UNITED STATES PATENT AND TRADEMARK OFFICE

Office Action Summary

10/697,757

DETAILED OFFICE ACTION

FIG. 2B

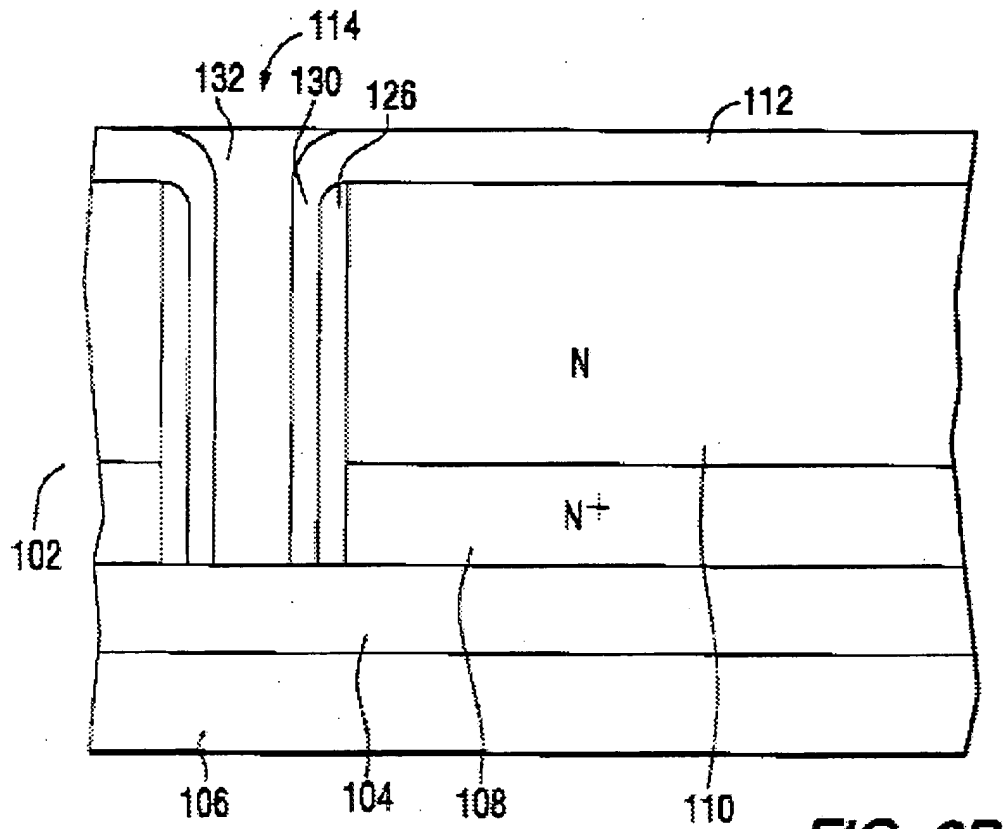
Woodberry (the abstract, fig 2B and 2D, column 3 lines 14-20,column 4 line 11) discloses a method of forming a semiconductor structure on a semiconductor wafer, the method comprising the steps of: forming an epitaxial layer on a least a portion of a semiconductor substrate of a first conductivity type; forming at least one trench through the epitaxial layer to at least partially expose the substrate, doping at least one or more sidewalls of the at least one trench with an impurity of a known concentration level so as to form a low-resistance electrical path between an upper surface of the epitaxial layer and the substrate, and substantially filling the at least one trench with a filler material.

Woodberry (the abstract, fig 2B and 2D, column 4 lines 1-3, trench 114) discloses a method of forming a semiconductor structure on a semiconductor wafer, wherein the step of forming the at least one trench comprises: forming an insulating layer on at least a portion of the epitaxial layer, forming at least one opening in the insulating layer corresponding to the at least trench, and etching through the epitaxial layer to at least partially expose the substrate.

Woodberry (the abstract, fig 2B and 2D, column 4 lines 1-2) discloses a method of forming a semiconductor structure comprising the step of forming at least one insulating Layer (fig 2B, layer 112) on at least a portion of the epitaxial layer.
